Lotmead, Wanborough

Response to LLFA Reasons for Refusal
(Condition 46: Outline Planning Permission
S/OUT/19/0582)

Response to LLFA Reasons for Refusal

FRA Addendum drawing showing catchments

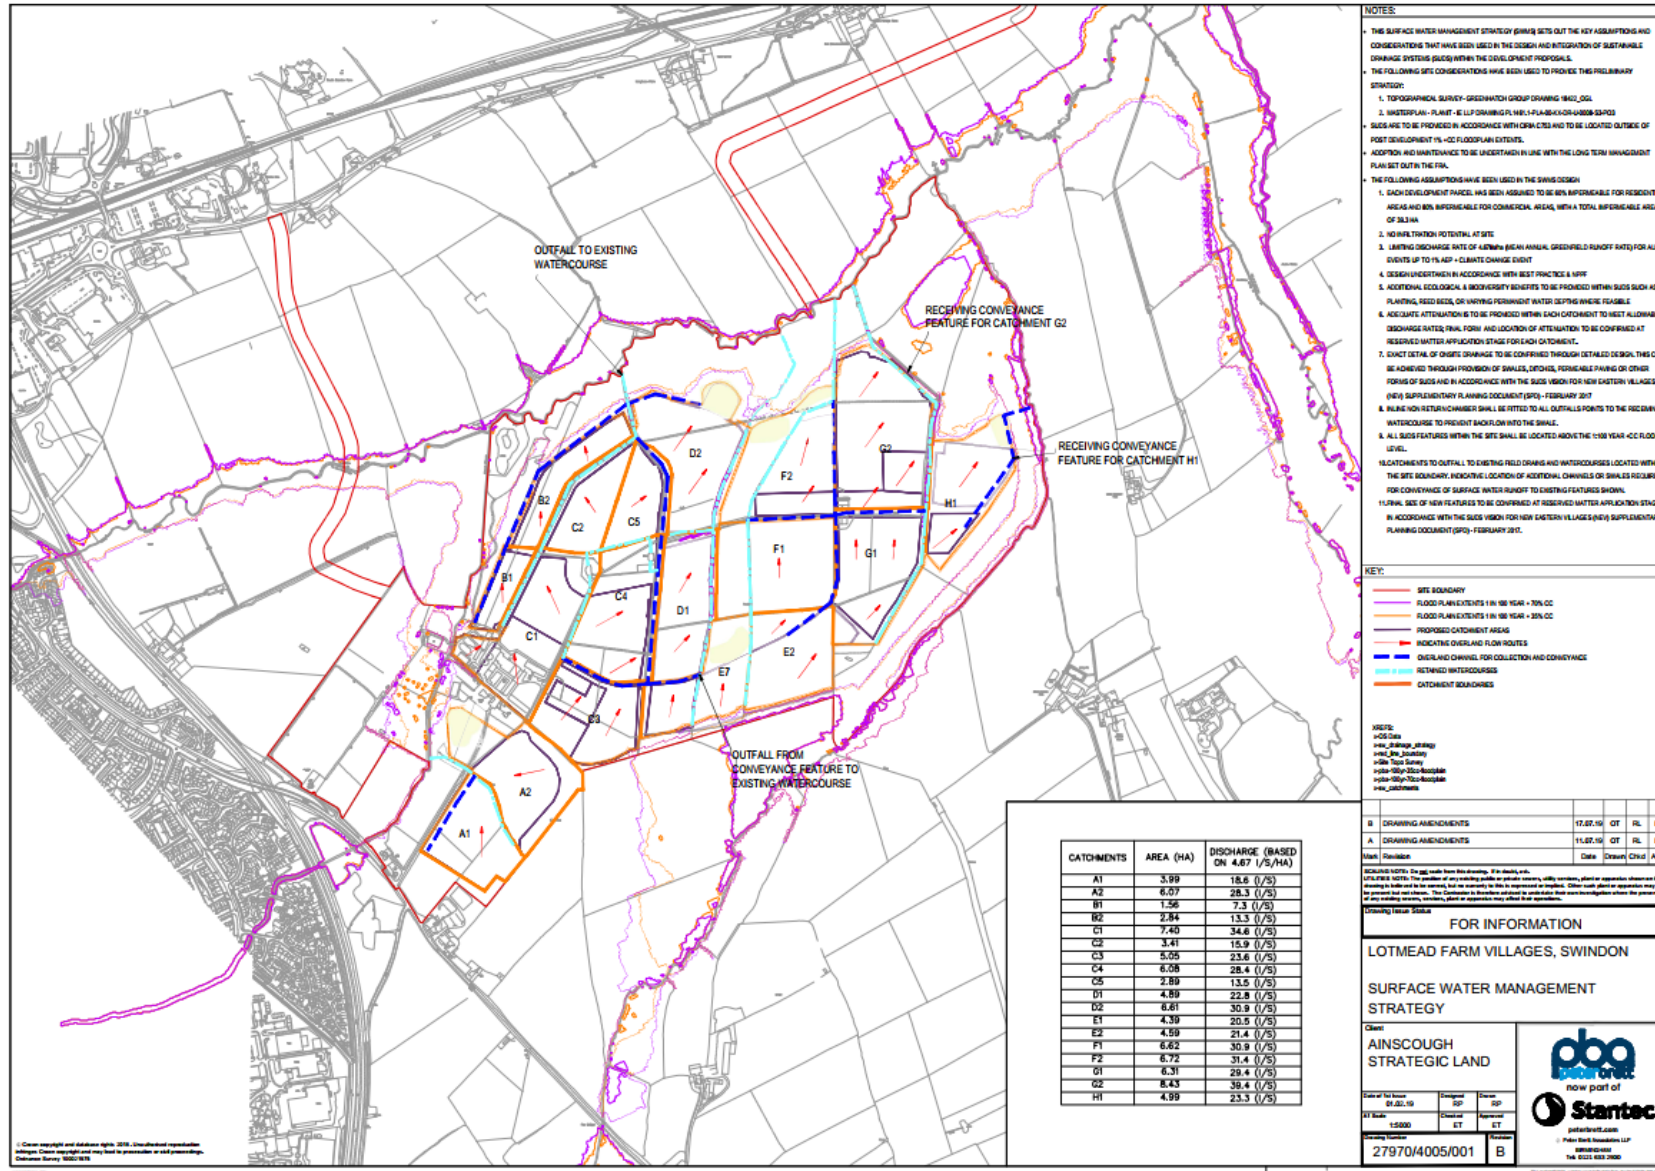
1. We note that the revised strategy has moved forward in addressing the outstanding issues. The catchments have been split up further to match the parameters of the agreed outline strategy with a further number of attenuation features shown across the site utilising existing ditches as outfalls.

The catchments have been updated on the Hydrock Drainage Strategy drawing in accordance with the PBA / Stantec Surface Water Management Strategy

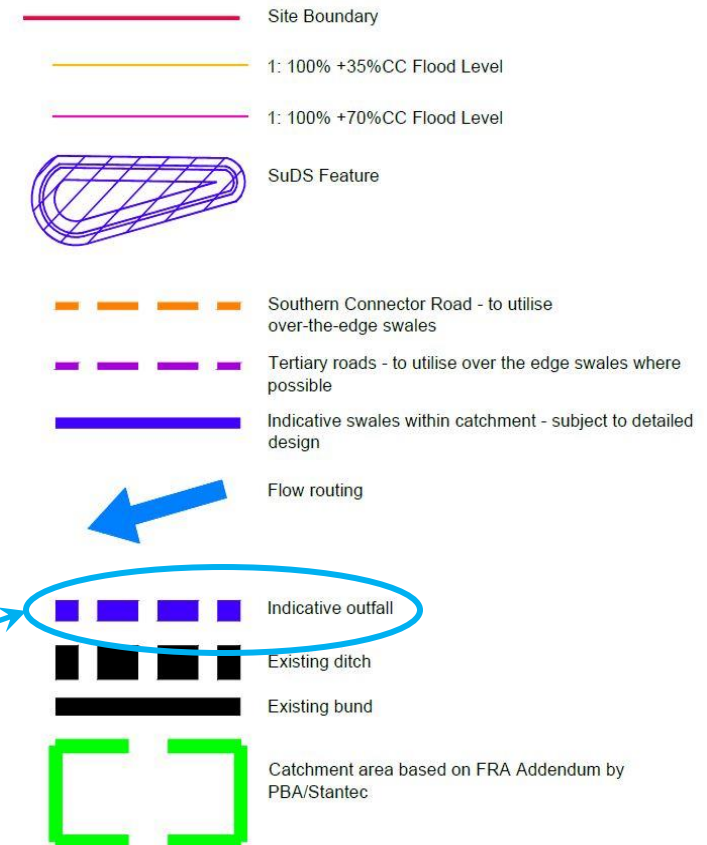
2. Whilst this has maintained the existing regime in many catchments across the site, some outfalls are still being proposed through long sections of pipe which is not acceptable.

The Hydrock Drainage Strategy drawing does not detail these as pipe's, ditches or swales, they are simply denoted on the drawing key as 'Indicative Outfalls' at this stage. How they are constructed will follow in the detail of condition 47.

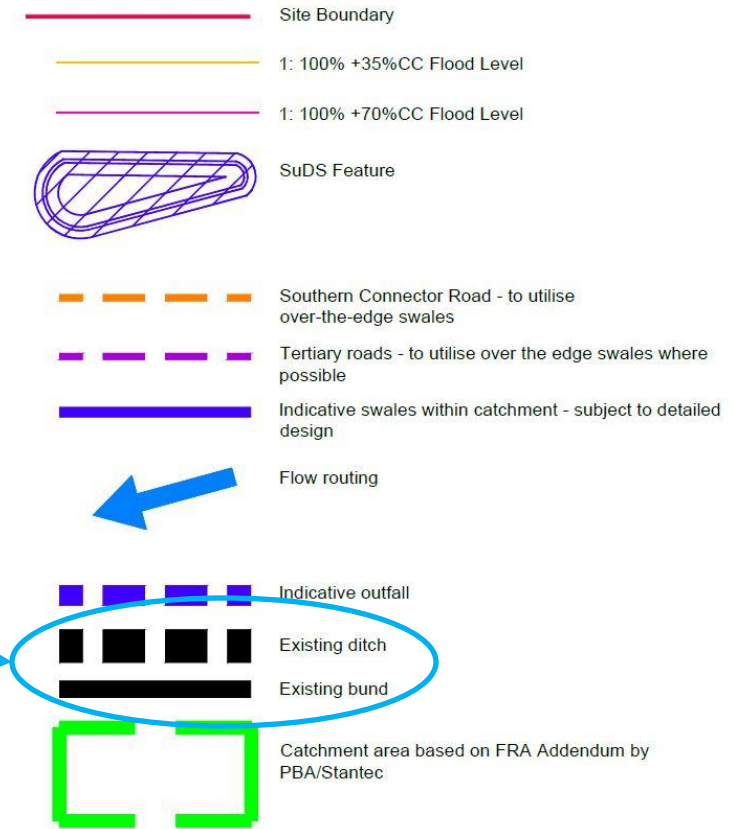
3. The level of strategic conveyance features, in the form of the existing ditches and further proposed swales that was shown on the outline strategy, still has not been provided.

a) All of the existing ditches are shown on the drainage strategy drawing (22006-HYD-PO-XX-DR-C-2211 Rev09) with black dashed lines.

Extract of Hydrock Drainage
Strategy Drawing

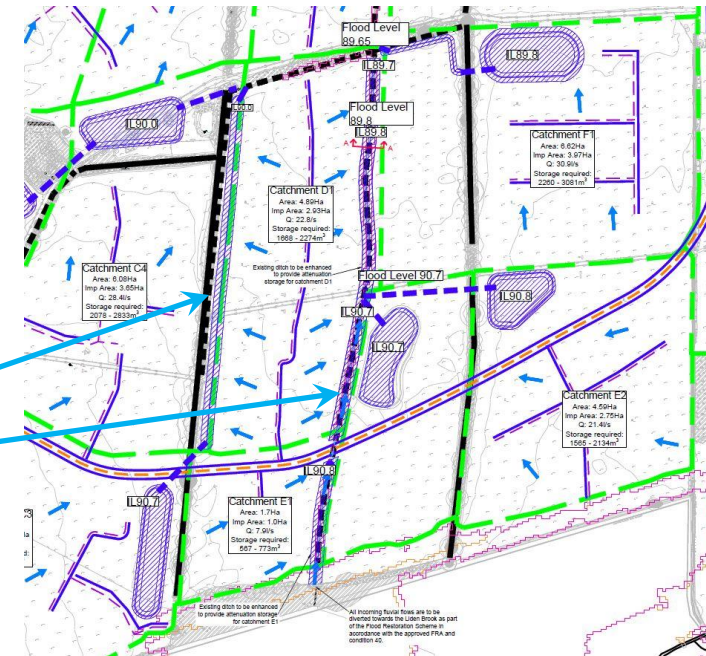
3. (cont.) The level of strategic conveyance features, in the form of the existing ditches and further proposed swales that was shown on the outline strategy, still has not been provided.

b) The approved FRA addendum plan (27970/4005/001 Rev B) show no ponds or swales, only 'overland channel for collection and conveyance' as identified in the drawing key.

Proposed swales are shown on the Hydrock drainage strategy drawing.

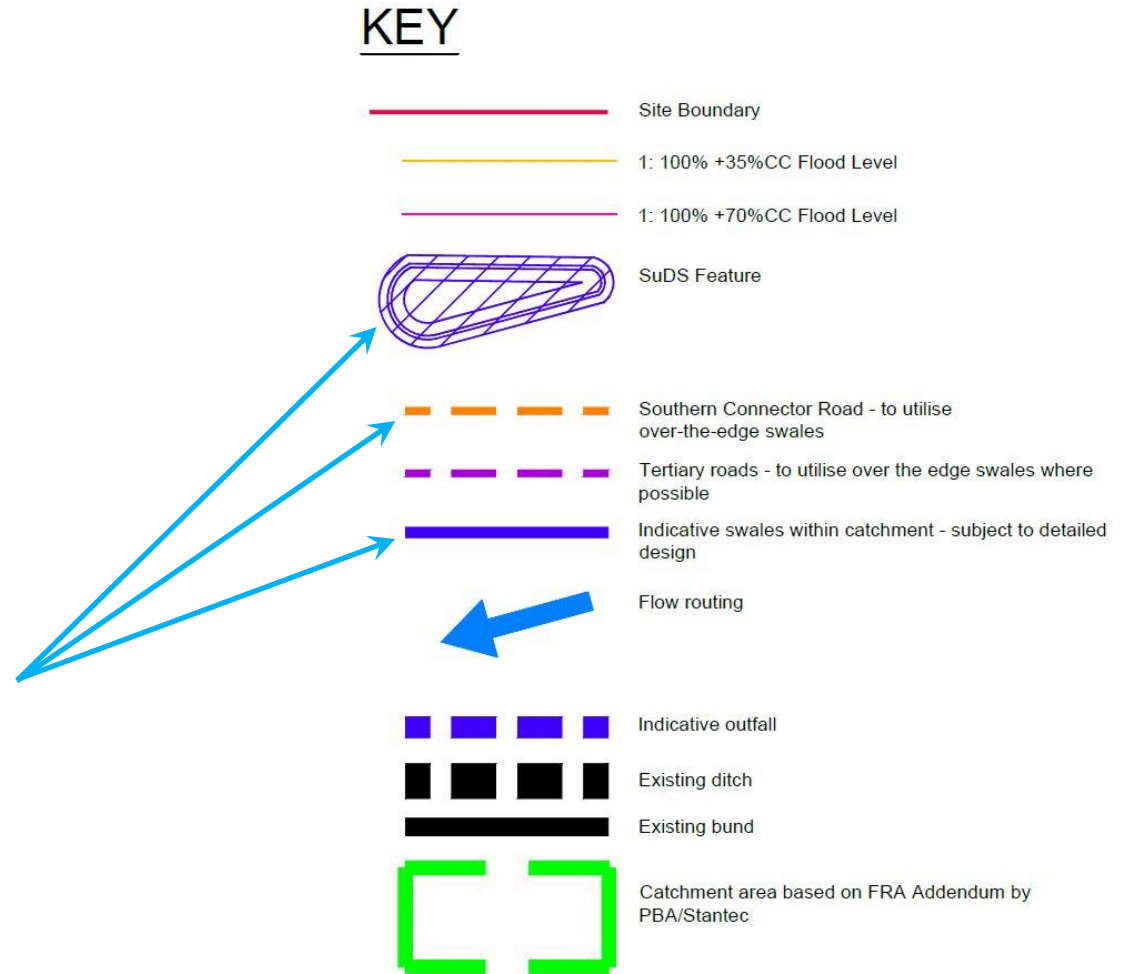
3. (cont.) The level of strategic conveyance features, in the form of the existing ditches and further proposed swales that was shown on the outline strategy, still as not been provided.

c) In addition the Hydrock drainage drawing shows many more features across the whole site as required by Condition 46

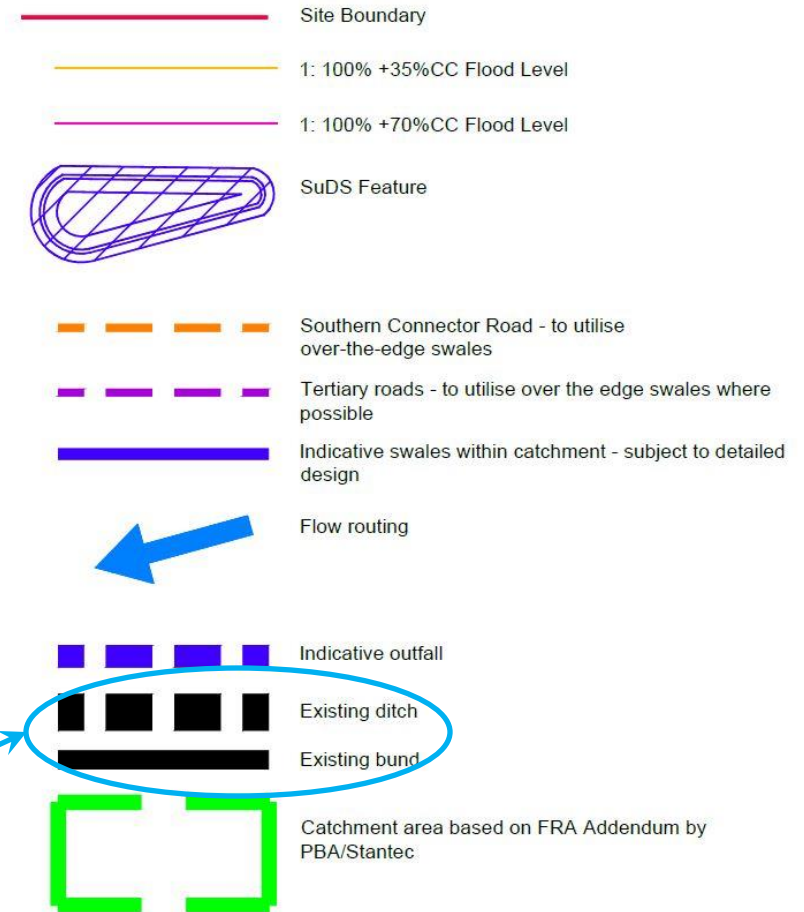
4. There are a number of areas where ditches exist but have not been fully surveyed due to vegetation. This strategic network whether it is proposed or existing, needs to be provided throughout the site to ensure all parcels can have an adequate outfall.

The topographical surveyor has re-surveyed the site and captured all ditches which are denoted on the Hydrock Drainage Strategy Plan. There are also bunds beneath some of the hedgerows which are denoted on the drawing and in the key.

Further clarification is required from the LLFA where the 'missing ditches' are situated

Figure2. Updated Restoration Works - removal of interceptor ditch

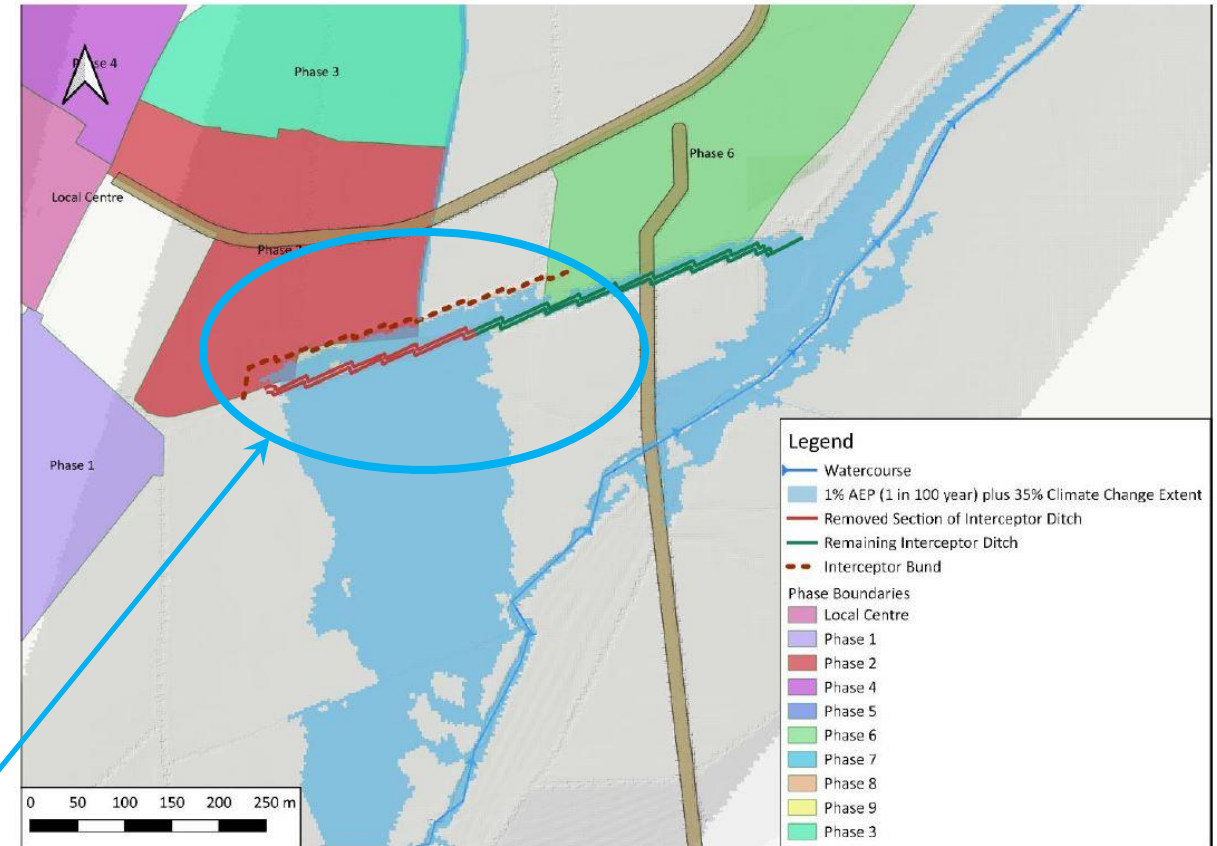
5. The revised strategy is still proposing the central ditch to be enhanced and utilised as storage but this is within the modelled fluvial flood extent so is not acceptable. This ditch needs to be maintained at its current level to allow flood flows to pass through and provide adequate outfalls from the parcels as well as ensuring groundwater levels are not increased post development.

Fluvial flows are being diverted away from the central ditch as part of the Flood Plain restoration works, this is a key principle agreed with the EA and is covered in the FRA & FRA addendum. This allows the central ditch to be used & enhanced. No fluvial flows will utilise this ditch once the flood restoration works are complete. The base level of the ditch will remain unchanged.

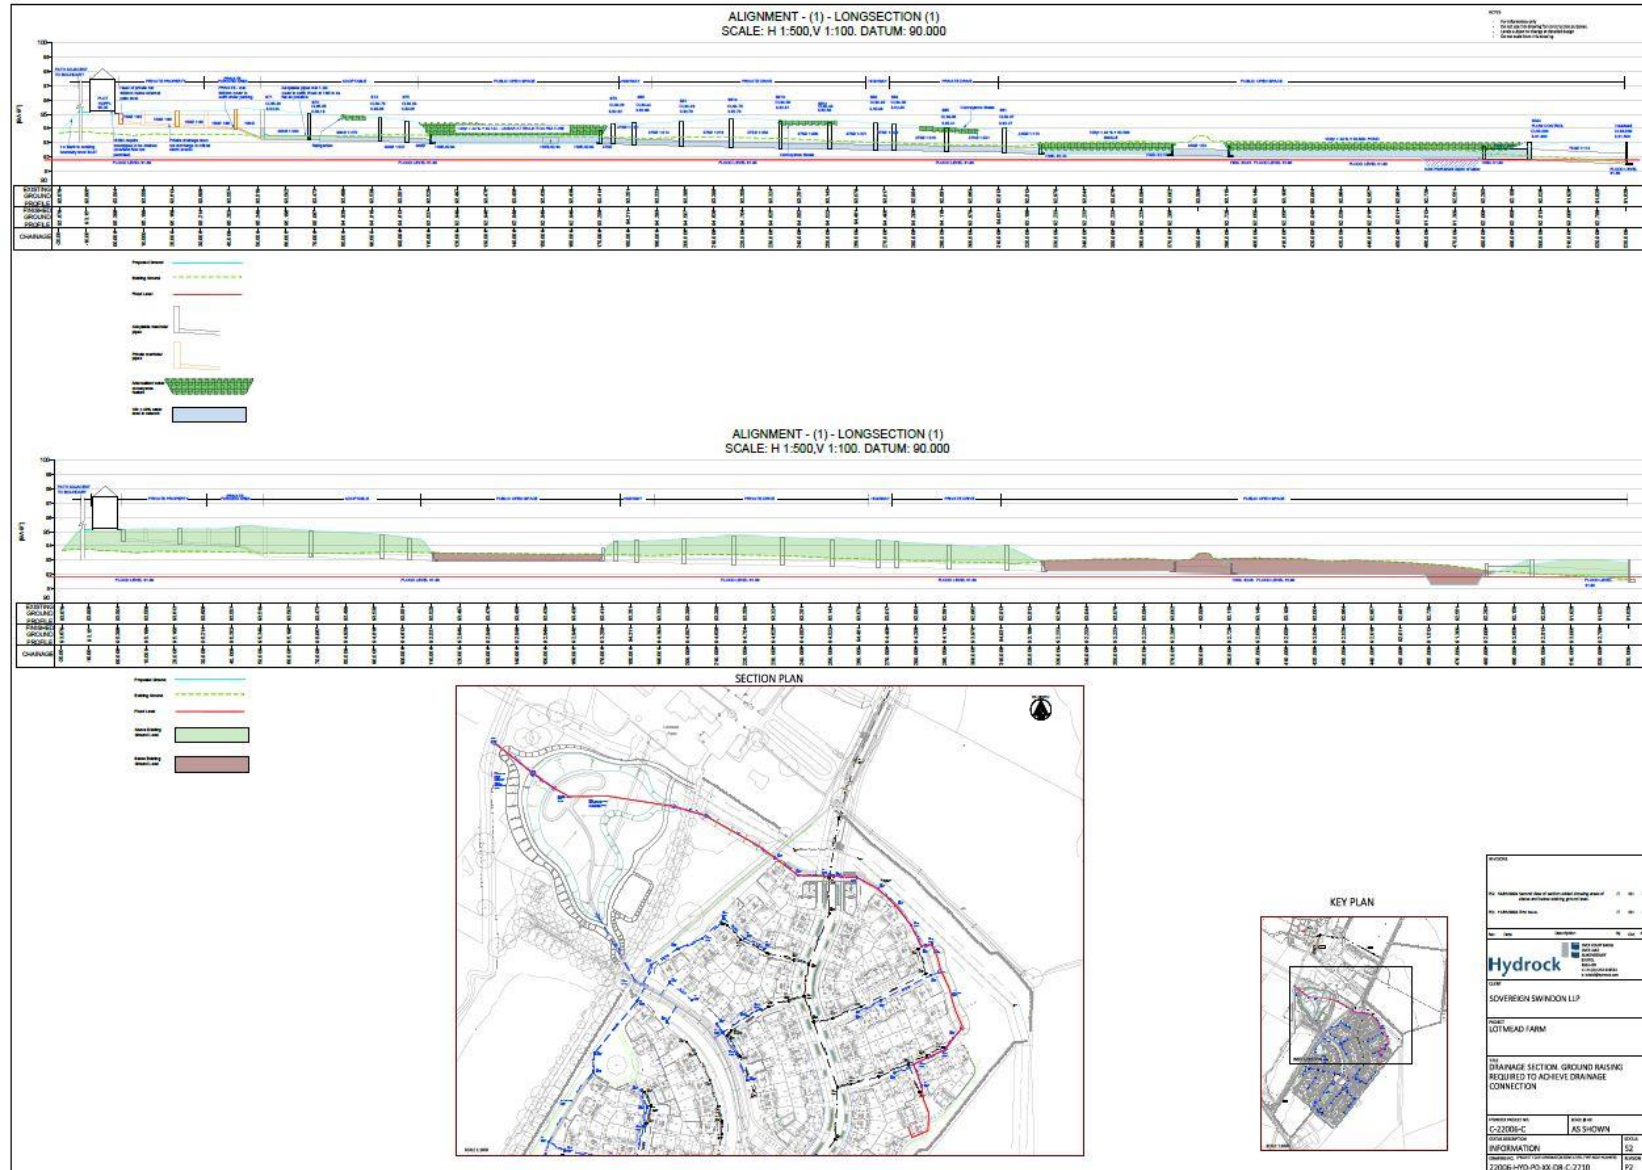
6. As stated in our previous comments, we do not expect the attenuation locations to be set as part of the strategic condition as the strategic condition is about ensuring the strategic watercourse and swale network is adequate to provide outfalls for the development parcels. We expect the required Source Control and attenuation features to be provided and agreed when the parcels come forward, through the phased condition, which would need to be in line with the parameters agreed in the FRA addendum and any further requirements set in the Strategic condition.

Condition 46 requires 'A strategic surface water drainage plan showing the proposed location of the proposed SuDS features'. It also requires us to demonstrate how SuDS techniques are incorporated and provide details of volumes and dimensions. These features are shown on the Hydrock Drainage Strategy Plan in order to meet the requirements of the condition and enable it to be discharged.
